Copier B/W

iR5055
iR5055N
iR5065
iR5065N
iR5075
iR5075N

iR5075-003
(F1-T01-N03-10011-01)

Countermeasure against lines in the sub scanning direction due to the poor positioning of the Terminal Plate

P-1 Image with lines

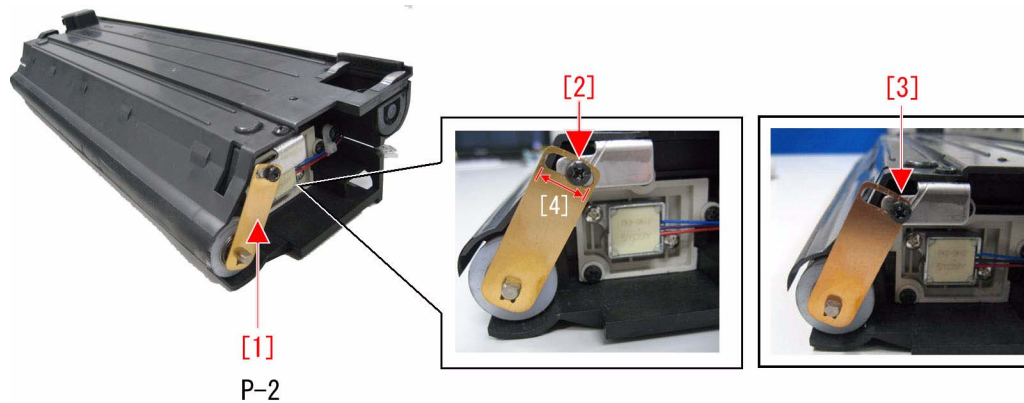
With the Developing Assembly which lot no. is 70401XXX through 70523XXX, lines may appear in the sub scanning direction due to the poor positioning of the Terminal Plate. (P-1)
